STAFF REPORT AND RECOMMENDATION TO THE DESIGN COMMISSION
DENIAL

CASE FILE: LU 16-251880 DZM
PC # 16-221061
REVIEW BY: Design Commission
WHEN: October 19 at 1:30PM
WHERE: CH2M Building, 2020 SW 4th Avenue,
Lincoln Room, Portland, OR 97201

Site Address: **930 NW 14TH AVENUE**

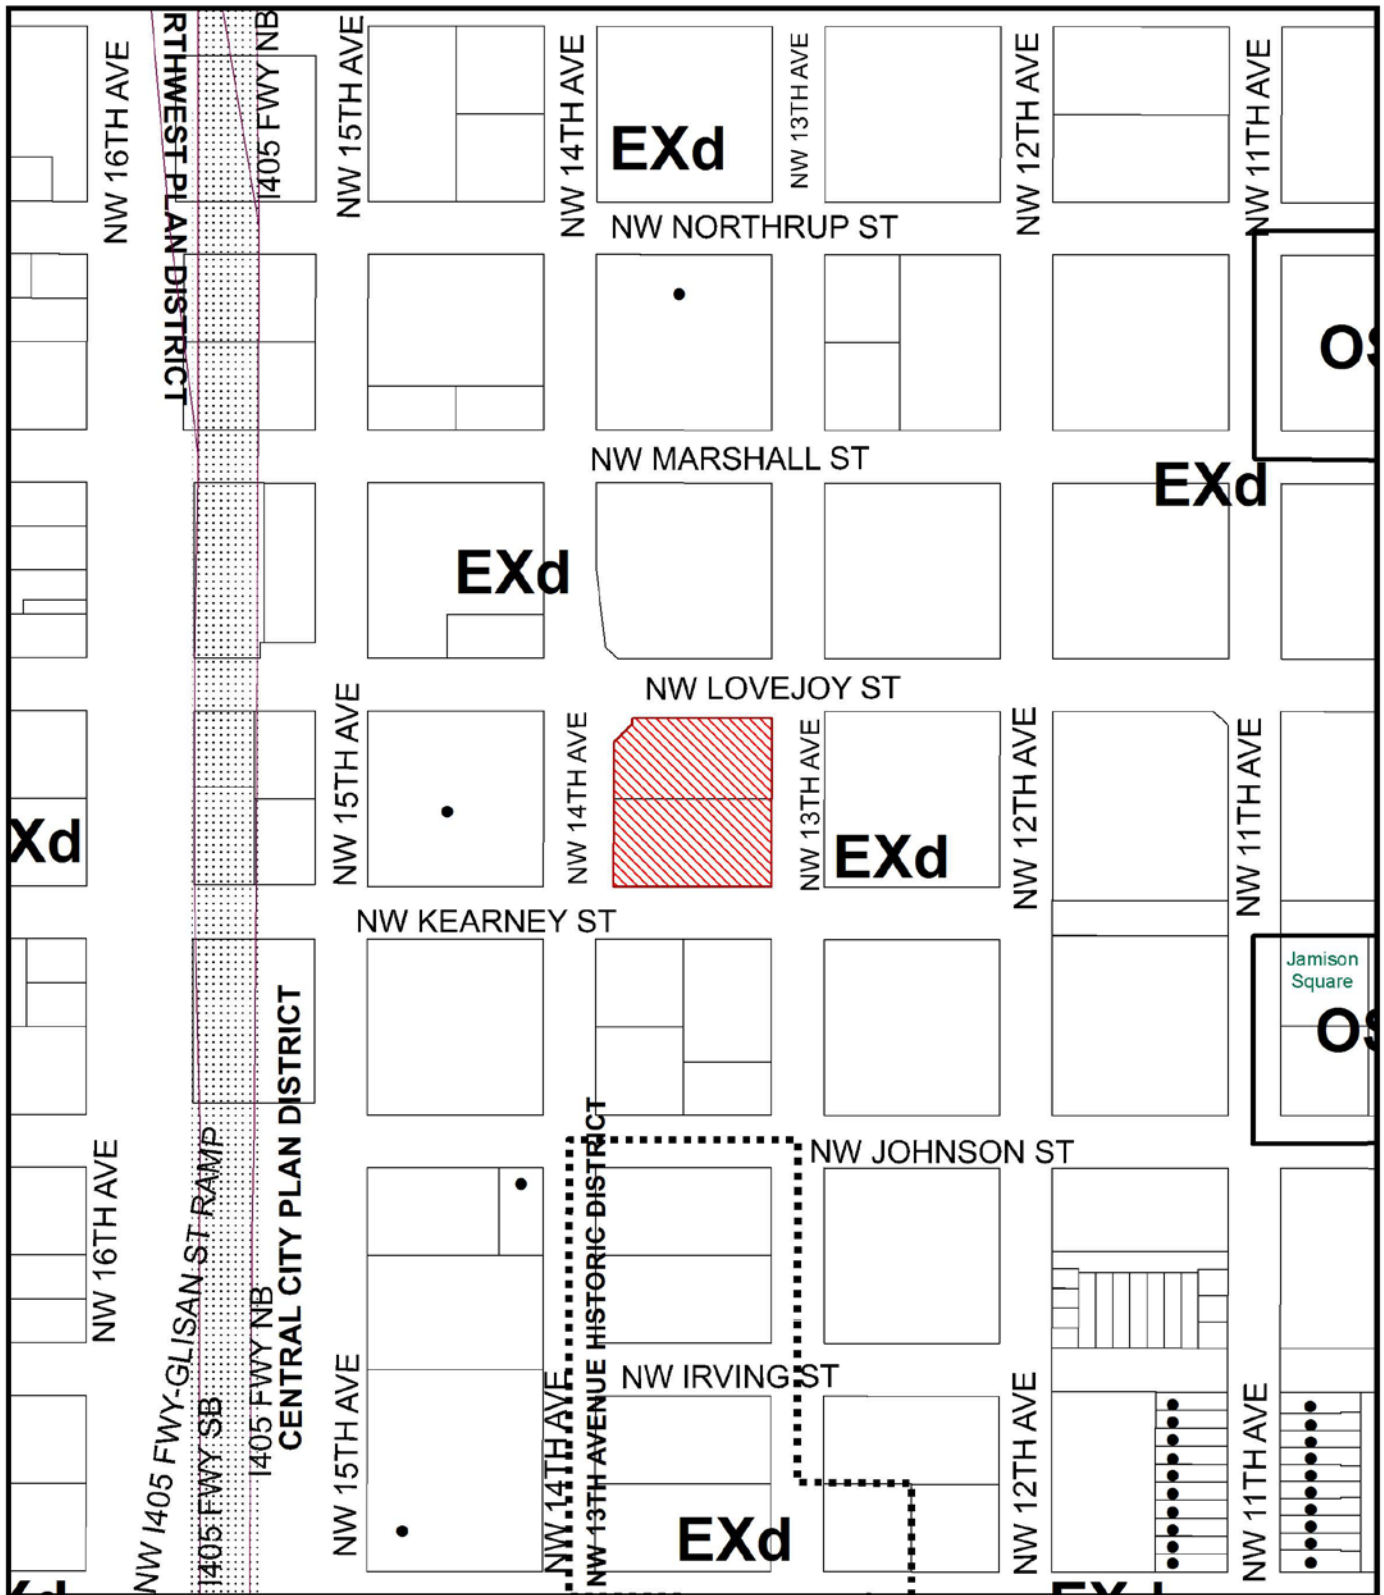
- **Rooftop:** The proposal is requesting a modification to the maximum height of the

building to allow amenity rooms on the roof top. This prohibited by code and is not approvable. The modification requests for the rooftop enclosures for mechanical, stairwell and cooling towers can only be evaluated once a revised design is submitted that does not include the amenity rooms.

- **Loading Dock Uplights.** Recessed uplights are proposed in the floor of the loading dock. This seems awkward given the public use and seating proposed in this space, and is atypical for all other River District docks. Refer to drawing C.42, Exhibit C.21.
